Clinch River Project  
Project No. 99902056

Subject: **Supplemental Response to NRC Feedback Questions on TVA's  
Response to eRAI-386**

TVA Supplemental Response to NRC feedback questions on TVA's responses to eRAI-386 dated May 4, 2023

FIGURE II.1-1 TVA NEW NUCLEAR ORGANIZATION

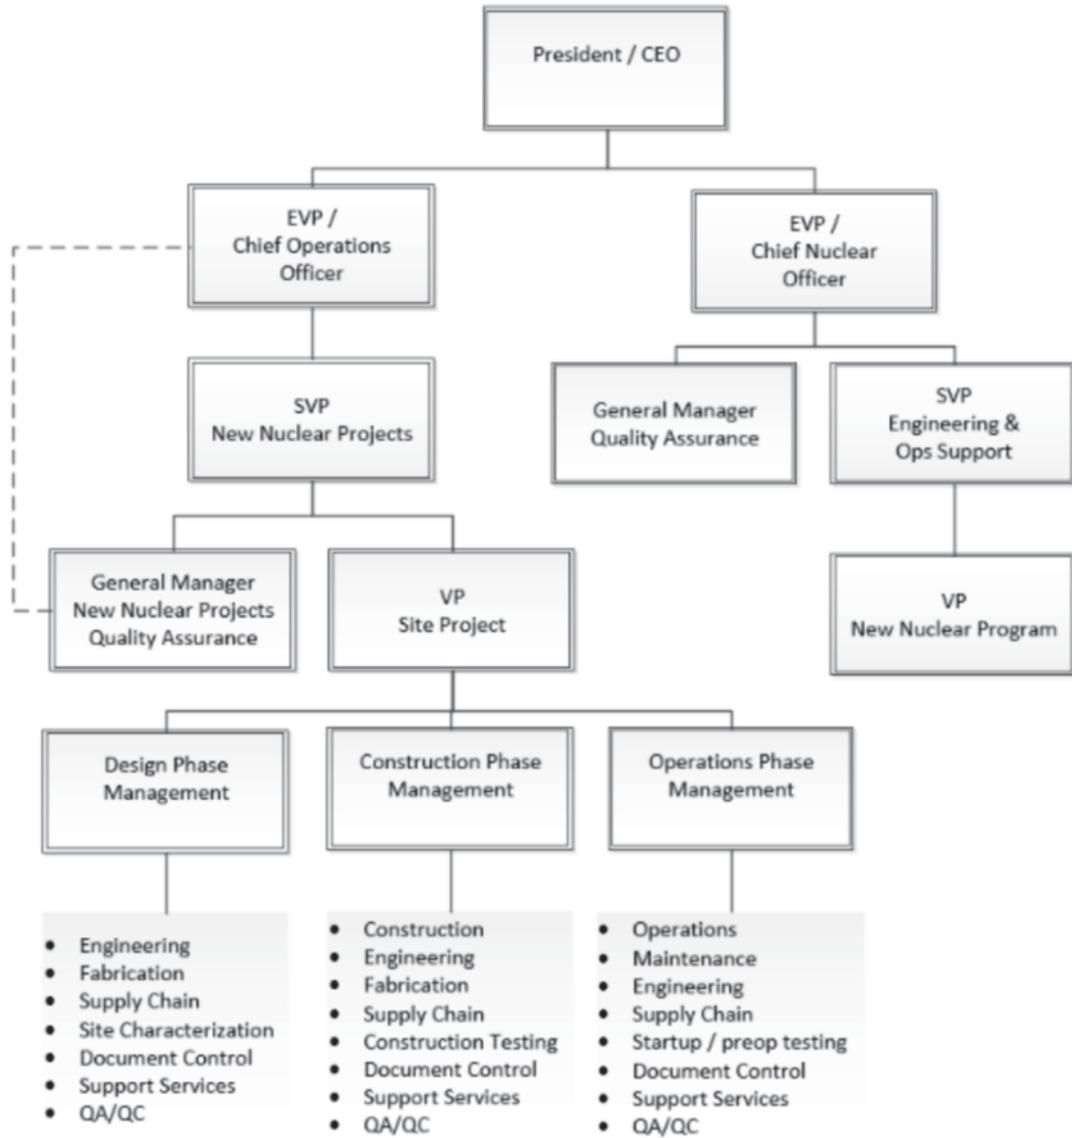
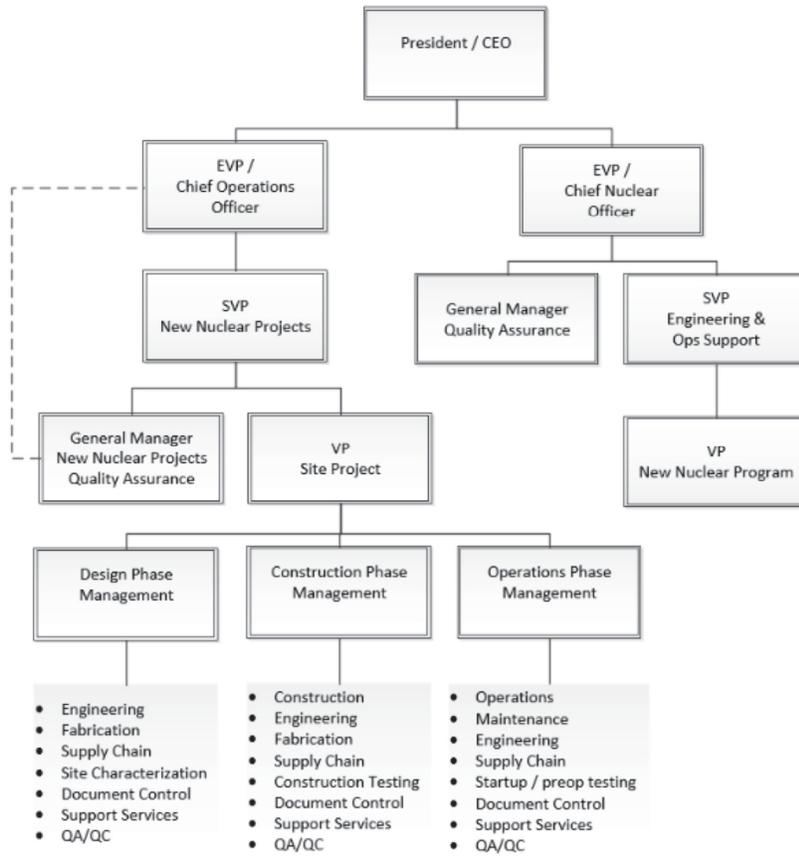
*Can TVA clarify what is meant by the sentence "The New Nuclear Program addresses global infrastructure and programmatic matters with siting..."*

Response: See attached reference FIGURE II.1-1 TVA NEW NUCLEAR ORGANIZATION.

Eliminated the phrase "global infrastructure and" in Part II Section 1 paragraph 2. Second sentence of paragraph 2 now states, "The New Nuclear Program group addresses programmatic matters with siting, licensing, and planning for multiple new nuclear projects across multiple sites."
